Accumulative Supplement to the

NORTH CAROLINA STATE BUILDING CODE VOLUME III HEATING, AIR CONDITIONING, REFRIGERATION AND VENTILATION

1979 EDITION

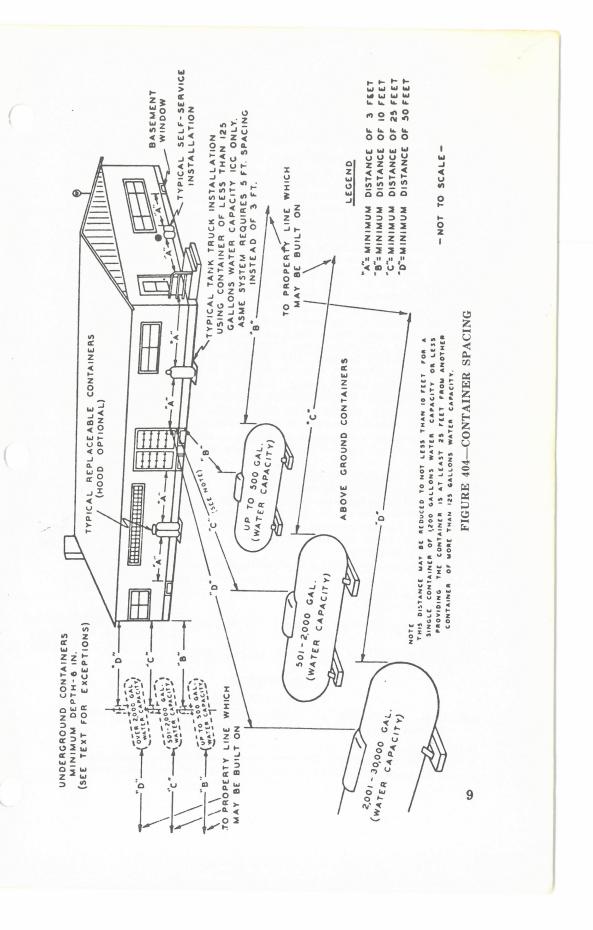
- (9-15-76) Page 4-3—Add new paragraph 404.0 as follows: 404.4 CONTAINER SPACING: Storage containers shall be located in accordance with Figure 404.0.
- (12-12-78) Page 5-4—Revise Section 505 as follows:
